Project No: 212142R

Noise Assessment Proposed Retirement Village 72 Wilsons Road Mount Hutton, NSW

A.0 – ADDENDUM

This addendum is written to address points raised by LMCC in response to the original acoustic assessment presented in the main body of this report

Figure A1 – Noise Monitoring Locations

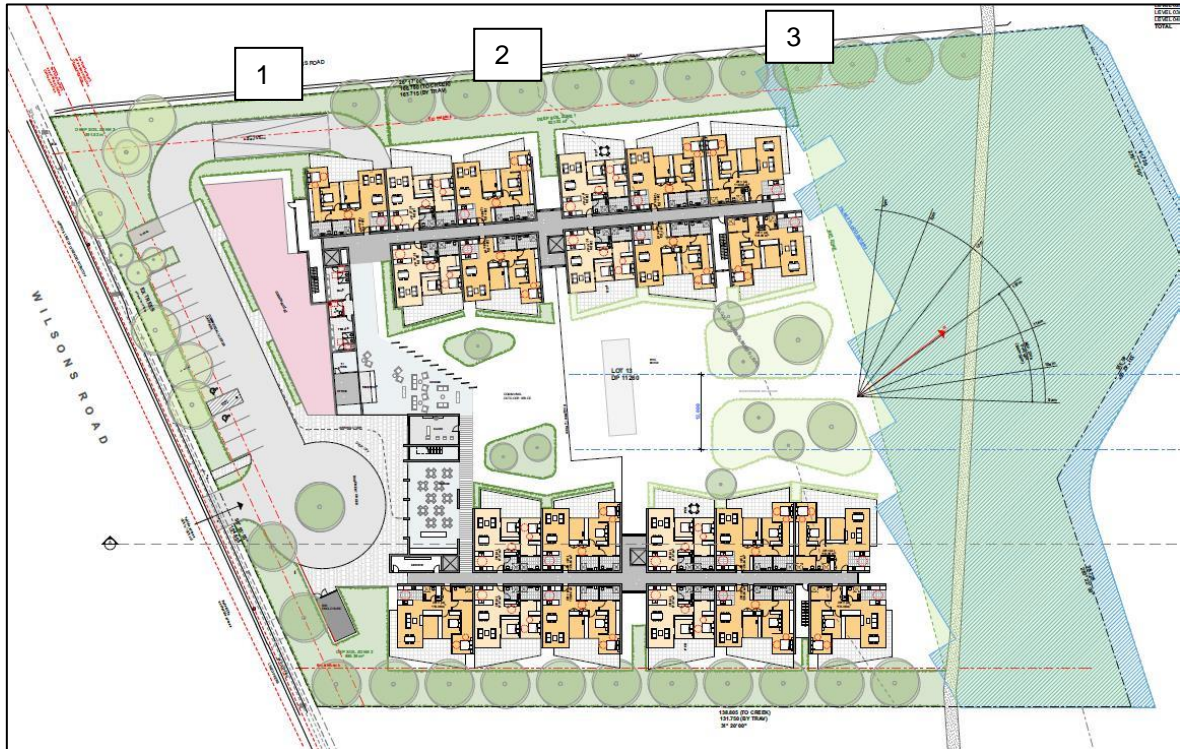
Acoustic report – “*The Acoustic Report prepared by Spectrum Acoustics assumes the tavern to be operating in compliance with the standard noise condition which raises concerns on the predicted noise levels. A noise monitoring (programme) should be undertaken to establish the existing acoustic environment. Further, the impact of noise from the plant/equipment associated with the proposed commercial spaces has not been considered in the assessment. Please provide a revised acoustic report addressing these matters. Any noise mitigation measures resulting from this assessment should be included in the proposal.*”

To quantify the existing acoustic environment, a noise monitoring programme was undertaken at various locations in the vicinity of the Lake Macquarie Tavern on Friday 14 January, 2022.

The most representative noise measurement locations and their relationship to the proposed development are shown in **Figure A1**.

Measurement location 1 is on the site boundary at a point that is in line with the front of the hotel. At this location the noise from the Tavern was from entertainment and from patrons leaving the premises.

Measurement location 2 is on the site boundary in line with the rear of the Tavern. At this location the noise from the Tavern was mainly from patrons in the premises (outdoor gaming area?) with some contribution from entertainment.

Measurement location 3 is on the site boundary in line with the rear of the proposed development. At this location the noise from the Tavern was mainly from entertainment.

The results of the noise monitoring show that, on the night of the measurements, the Lmax noise from the Tavern was at levels that were generally lower than the sleep disturbance screening criterion.

Upgrading the windows of the bedroom to include thicker glazing and more acoustically solid frames would result in lower internal noise levels when compared to the sound transmission properties of standard glazing.

The results in the tables above show that there is a general decrease in the internal noise levels within the bedrooms with an increase in the thickness and acoustic integrity of the glazing. Maximum internal noise levels of 36 to 39 dB(A) are considered unlikely to cause sleep disturbance.
